Case File Number: PLN18-088-R01 May 12, 2021

Location: 2715 Adeline Street (See map on reverse)

Proposal: Revision to floor plans and height of previously-approved project

Staff Recommendation: Provide design comments and recommendations

Proposed Revised Design

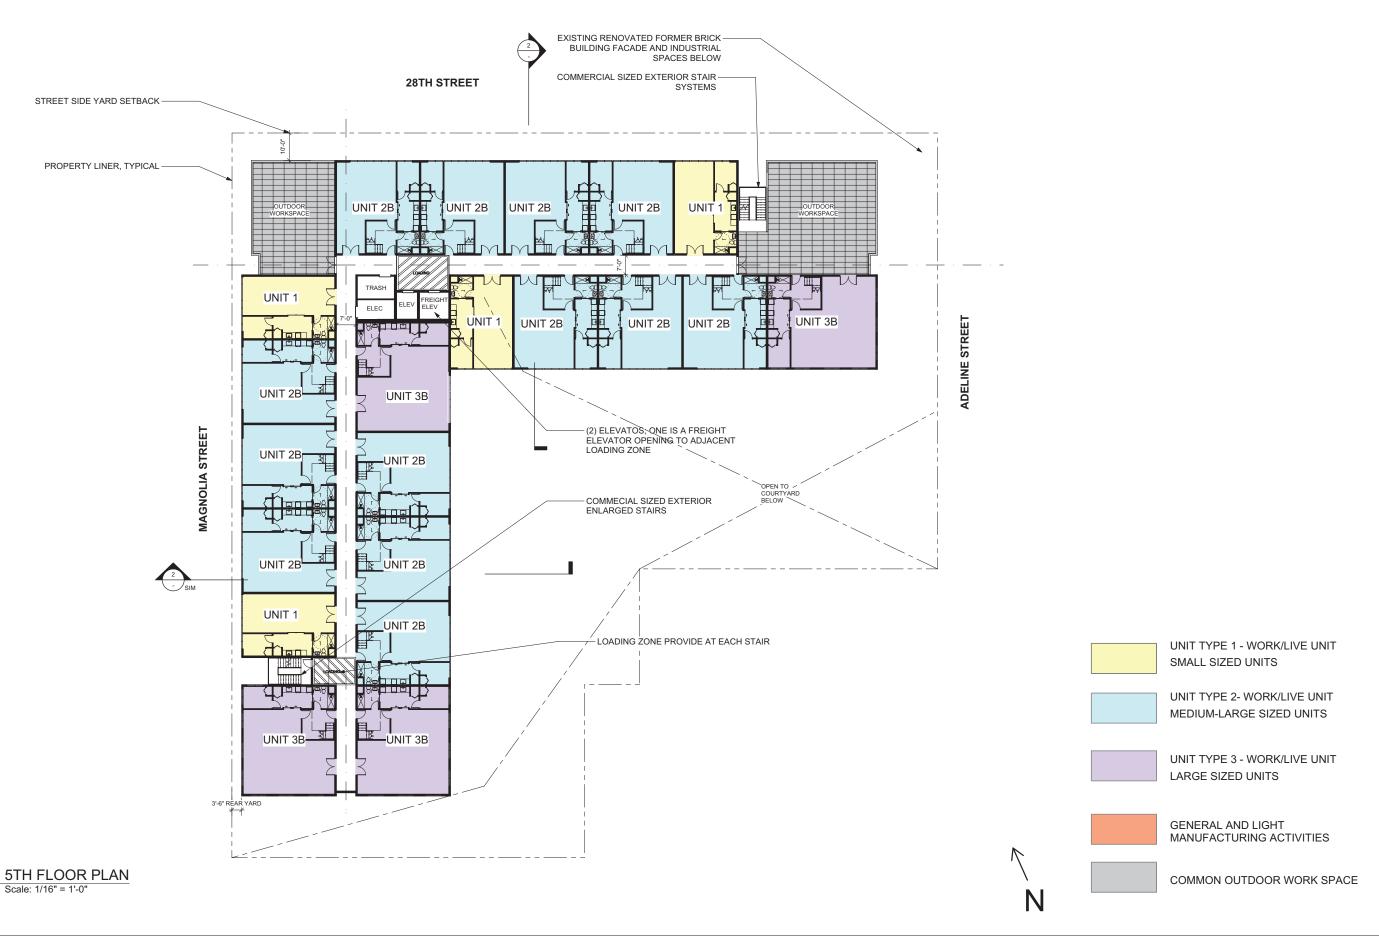
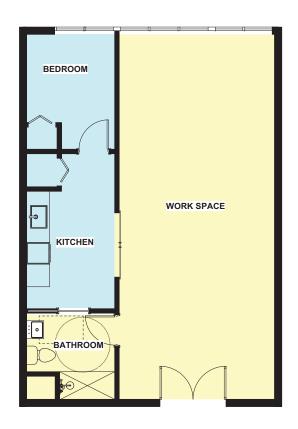
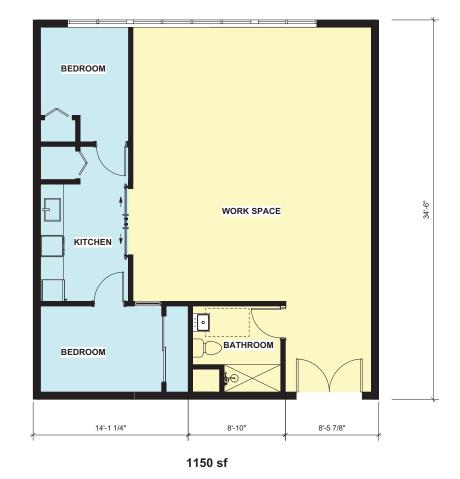
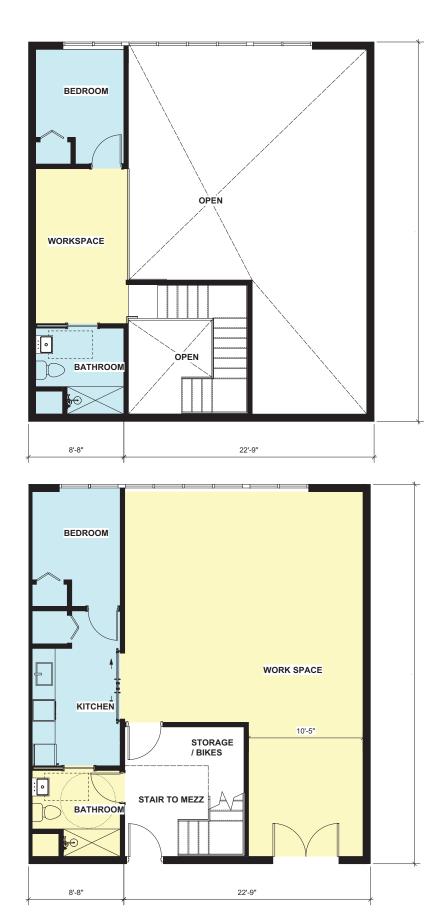
- That the layout of nonresidential floor areas within a unit provides a functional and bona fide open area for working activities; The applicant revised the floorplans has eliminated the mezzanines with the exception of the fifth-floor units, rearranged the layout of all units to open them up to minimize obstructions and enhance functional and bona fide open areas for working activities.
- That the floor and site plan for the project provide units that are easily identified as businesses and conveniently accessible by clients, employees and other business visitors Compared to the originally approved layout, the proposed revisions offer better work spaces. Nevertheless, the floor to floor heights of the 2nd, 3rd and 4th floors are now reduced from 16 feet to 12 feet.

the former layout, the reduced floor-to-floor height from 16 feet to 12 feet may be limiting for some types of light industrial uses that require taller floor-to-ceiling heights.

1. Comment and make recommendations on the proposed revisions to the floor plans, elevations and building height.
